NL-14-035

SUBJECT: Proposed Changes to Indian Point 3 Technical Specifications Regarding Reactor
Vessel Pressure/Temperature Limit Curves
Indian Point Unit Number 3
Docket No. 50-286
License No. DPR-64

MARKUP OF TECHNICAL SPECIFICATIONS PAGES FOR PROPOSED CHANGES REGARDING REACTOR VESSEL PRESSURE/TEMPERATURE LIMIT CURVES

Figure 3.4.3-1:
Heatup Limitations for Reactor Coolant System

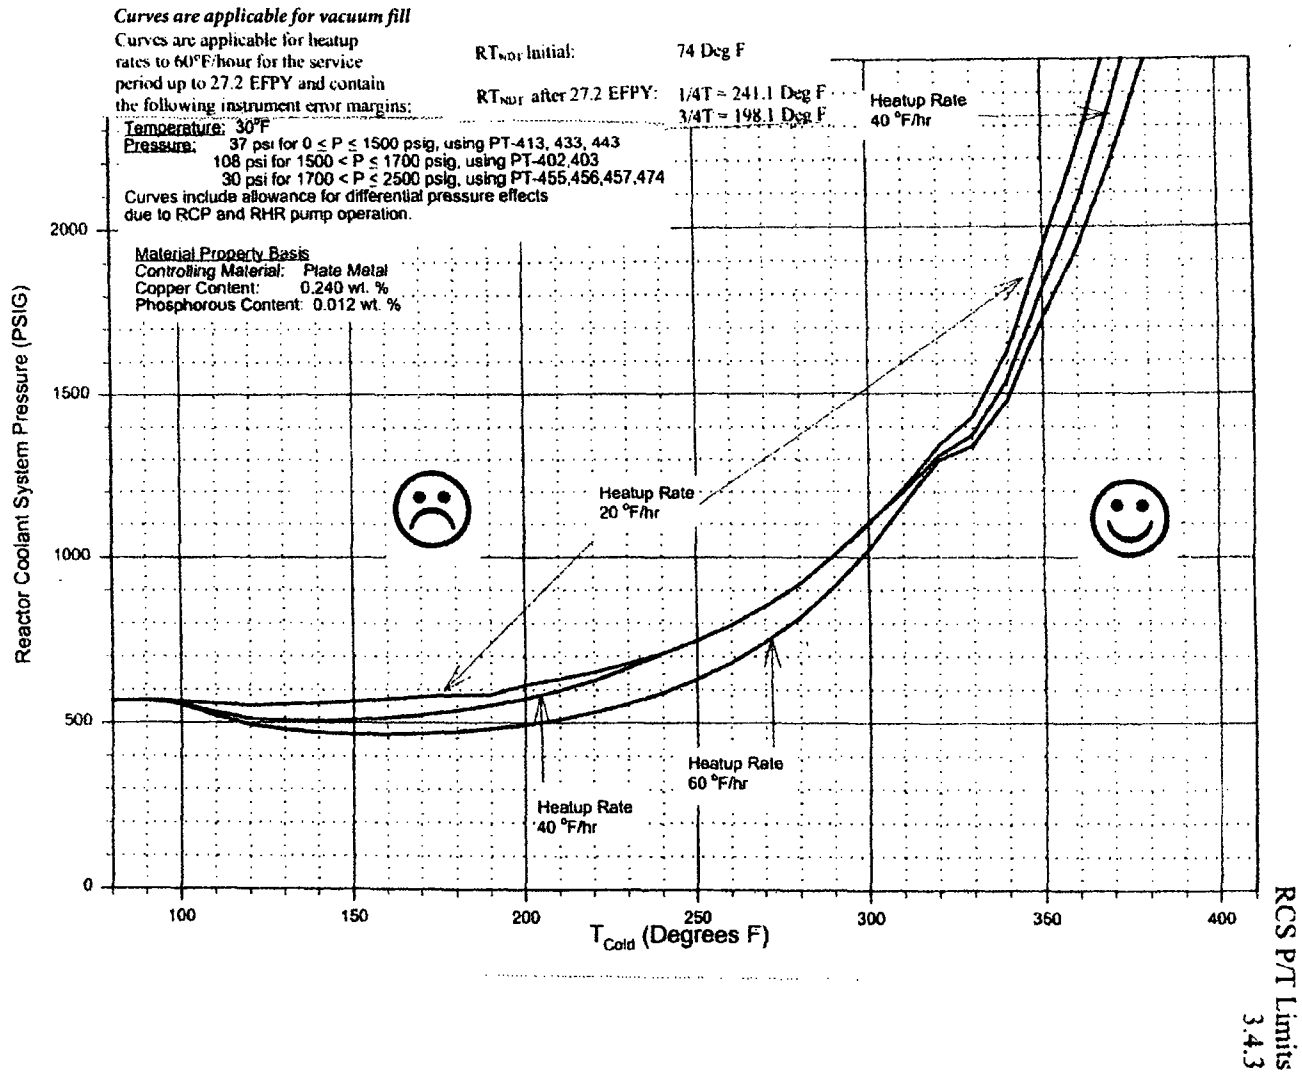
Entergy Nuclear Operations, Inc (Entergy) is requesting an amendment to Operating License DPR-64, Docket 50-286 for Indian Point Nuclear Generating Unit No. 3 (IP3). Technical Specifications Figure 3.4.3-1, Heatup Limitations for Reactor Coolant System, Figure 3.4.3-2, Cooldown Limitations for Reactor Coolant System, and Figure 3.4.3-3, Hydrostatic and Inservice Leak Testing Limitations for Reactor Coolant System are being revised to indicate that the curves are applicable for vacuum fill. The change is necessary to account for a short period of time during startup when a vacuum is drawn in the Reactor Coolant System (RCS) while filling with water. The specific proposed changes are to add a note to the Figures that the "curves are applicable for vacuum fill" as shown in Attachment 2.

Text changes on Figures indicated by Bold/Italics for additions
